PLANNING COMMISSION

AGENDA
TUESDAY, JANUARY 7, 2025

5.1 Hearing to consider a request for a Municipal Code Amendment, Development Code Amendment, Conditional Use Permit Modification, Development Agreement, Site Plan Design Review, and Site Plan Design Review Modification for the Parkwest Casino 580 Expansion Project and city-wide cardroom operations.

PLANNING COMMISSION STAFF REPORT **ITEM NO. 5.1**

DATE	06/28/2022
SCALE	1" = 20'
DESIGNER	pjr
DRAWN BY	ds
JOB NO.	A18649
SHEET	L1.0
OF	13 SHEETS

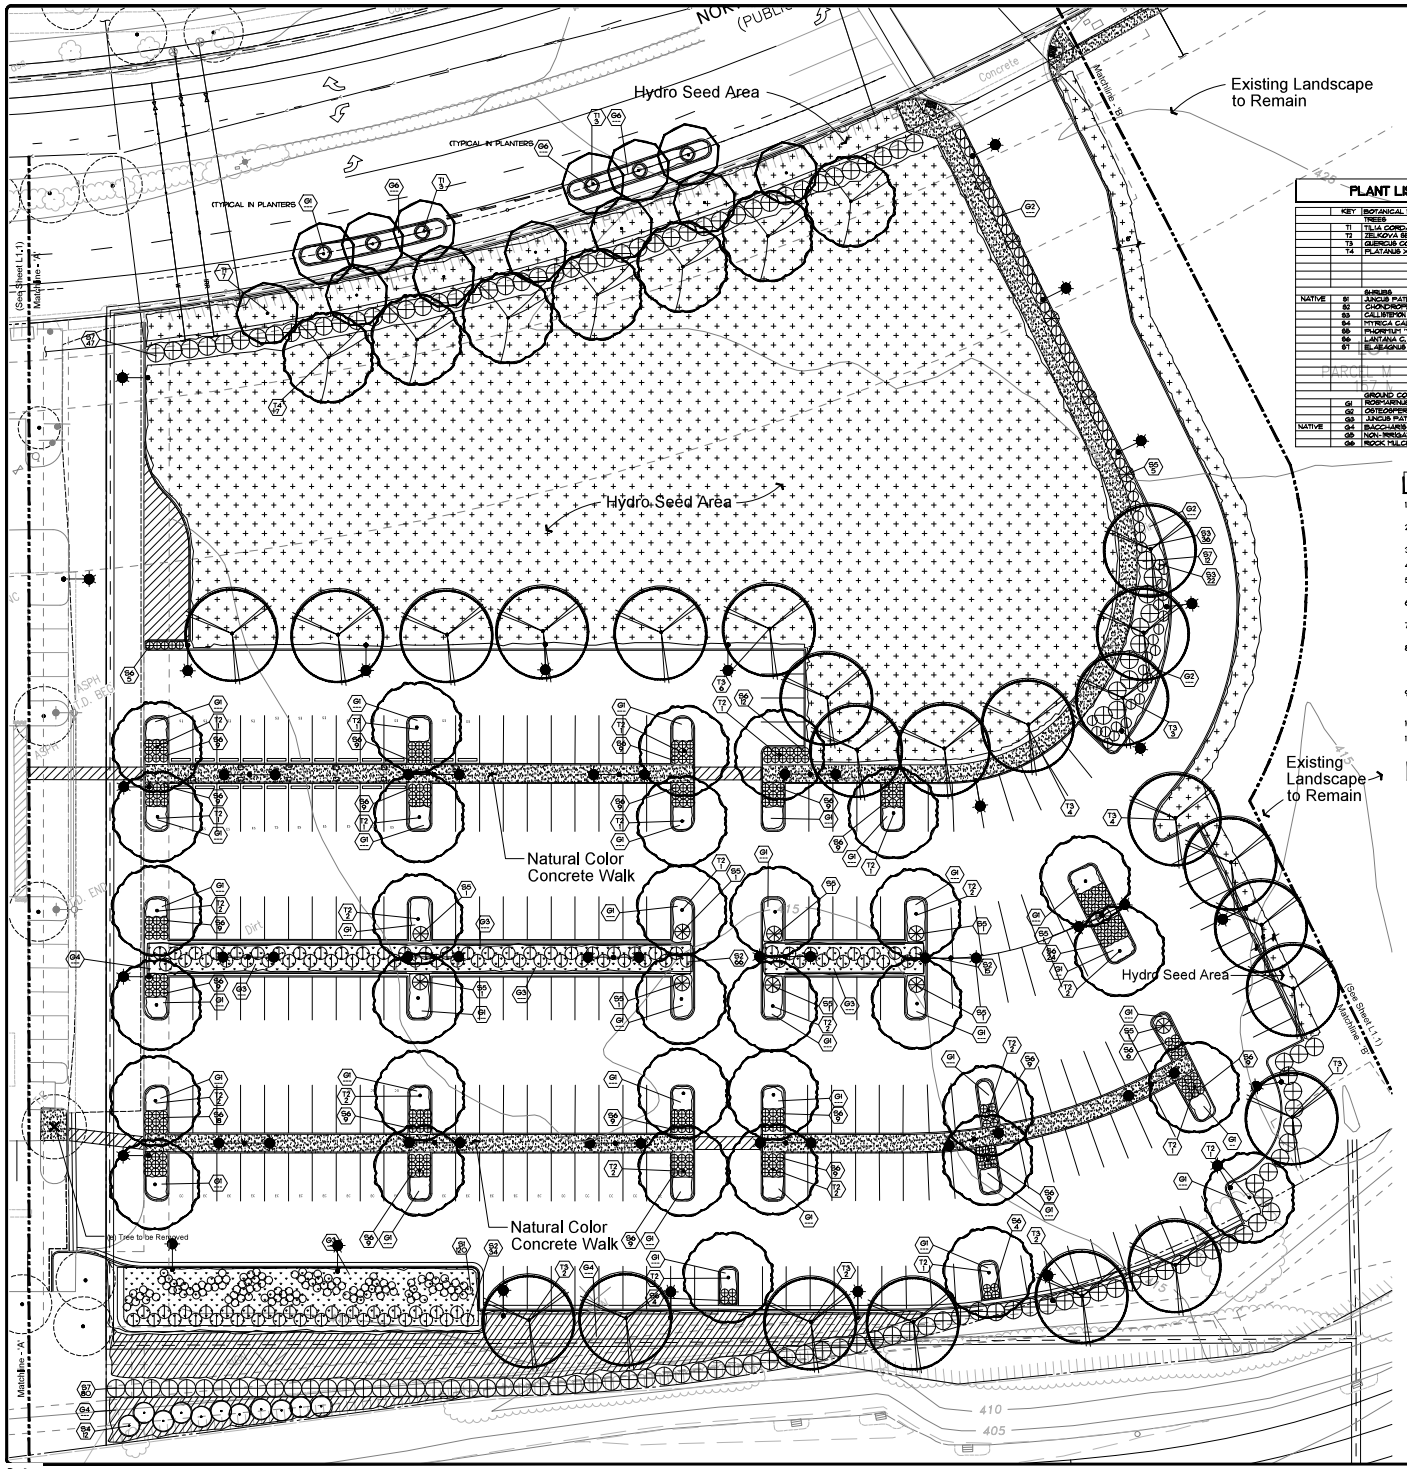
The Project includes landscaping around the southern edge of the property, adjacent to I-580. Per the Community Character Element of the General Plan, the Scenic Corridor is defined as the area within 3,500 feet of each side of the centerline of I-580, and visible from the I-580 roadway. By definition, this includes the Project site. General Plan policy states that landscaping, including trees, shall be planted in a manner such that when mature, does not create a wall-like effect that substantially obscures views of the ridgeline (Goal CC-4, Objective CC-4.10, Policy P3). To ensure that this policy is met, staff recommends the following modification to the landscaping plan:

- Along the length of the southern property line only, replace proposed shrubs S4 and S7 as identified on sheet L1.0 to a mix of low (i.e., 24-36 inches maximum height) ground cover. Refer to Attachment 13.
- Remove the four westernmost proposed Scarlet Oak trees proposed along the southern property line as shown in Attachment 13. To the extent feasible, relocate the proposed Scarlet Oak trees along the easternmost driveway to compensate for the removed trees.

a. Along the length of the southern property line only, replace proposed shrubs S4 and S7 as identified on sheet L1.0 to a mix of low (i.e., 24-36 inches maximum height) ground cover. Refer to Attachment 2 for a detailed markup.

Figure 1
Site Plan

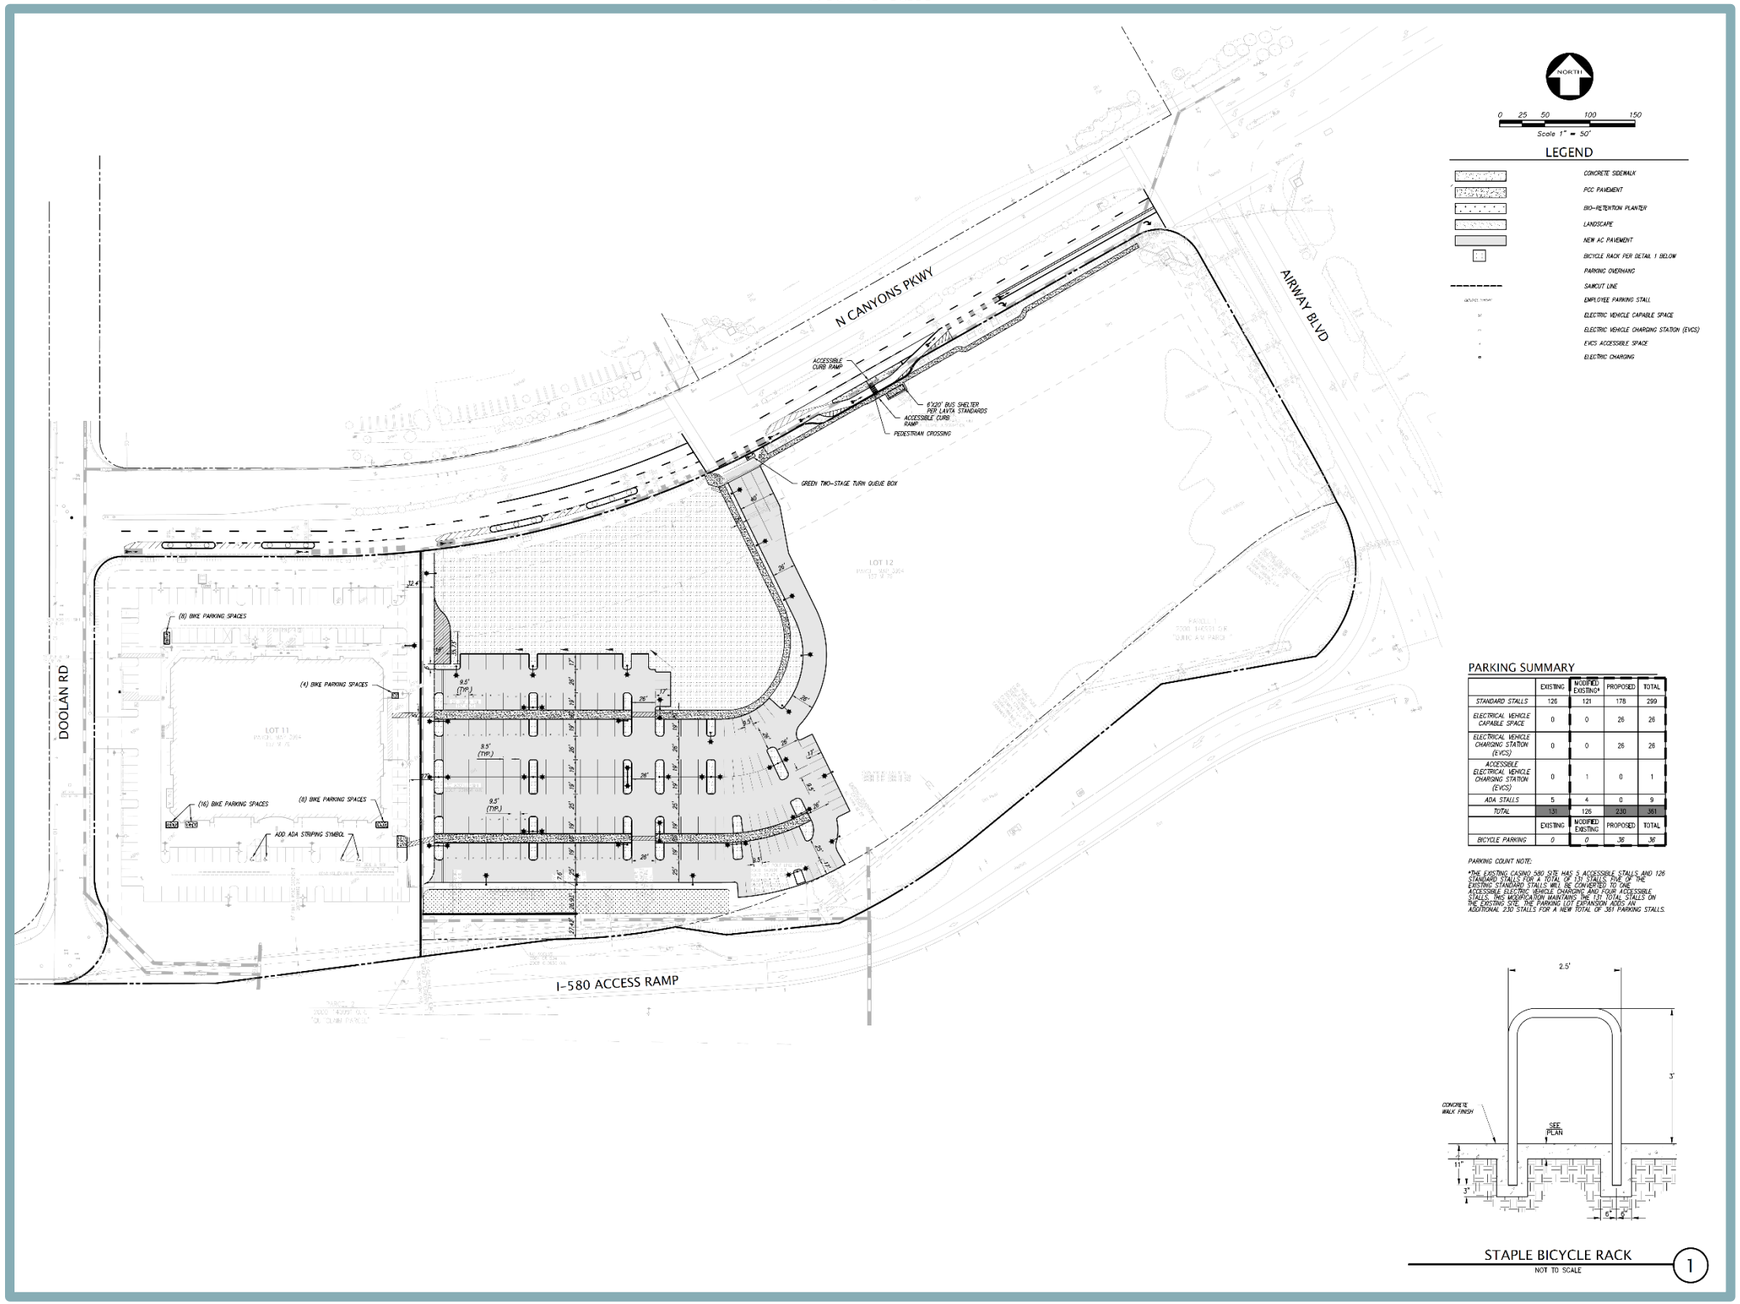
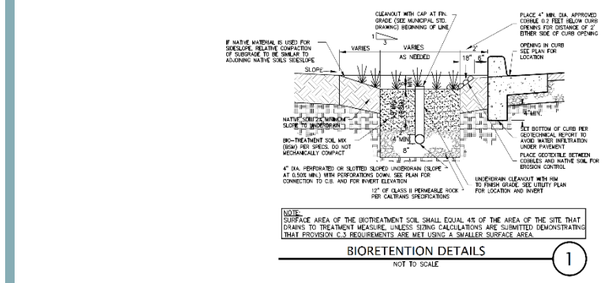
In response to the comment, the project applicant has modified project plans to avoid all California Department of Transportation (Caltrans) right-of-way, easements, and infrastructure. The layout of the proposed project has shifted slightly, but the number of parking stalls would remain unchanged. The proposed project's storm drain infrastructure would connect to the City's existing storm drain that travels through the project site. Therefore, Figure 3 and Figure 4 of the IS/MND have been replaced with those shown at the end of this document.

> Stormwater runoff from the new impervious surfaces within the DMA~~s~~ would be directed to the ~~three~~ on-site bioretention planter~~s, with two located within DMA 1~~ as part of Treatment Control Measure (TCM) 1~~, and one located within DMA 2 as part of TCM 2~~. (see Figure 4).

Storm water runoff within the project site would flow to ~~three~~ a bioretention planter~~s~~ located in the proposed parking lot that would provide treatment and retention of the on-site stormwater runoff. As shown above in Figure 4, the total treatment area on-site would be equal to new impervious area plus 10 percent of the landscaped area, as required by the County C.3 Stormwater Standards. Thus, adequate storage would be provided on-site.

DATE	06/28/2022
SCALE	1" = 20'
DESIGNER	PJR
DRAWN BY	ds
JOB NO.	A18619
SHEET NO.	L1.0
OF SHEETS

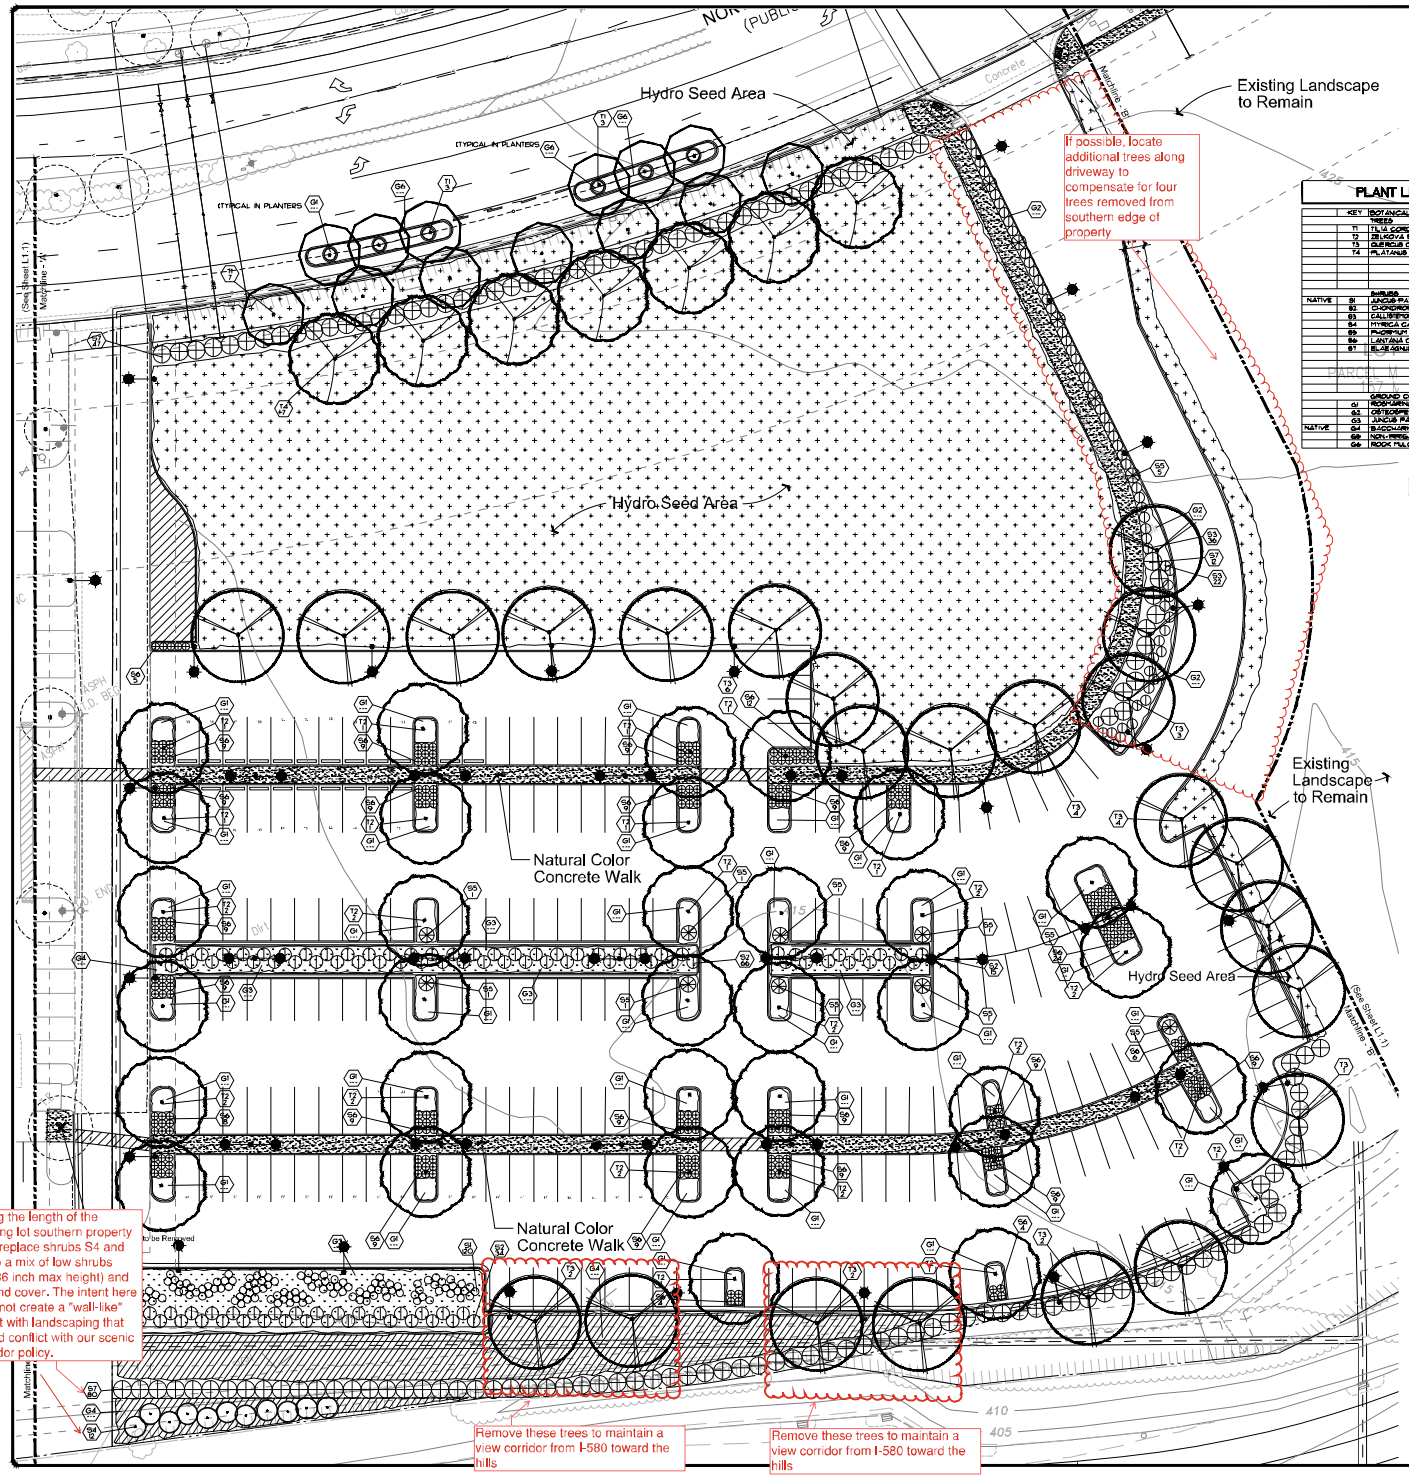
a. Along the length of the southern property line only, replace proposed shrubs S4 and S7 as identified on sheet L1.0 to a mix of low (i.e., 24-36 inches maximum height) ground cover. Refer to Attachment 2 for a detailed markup.
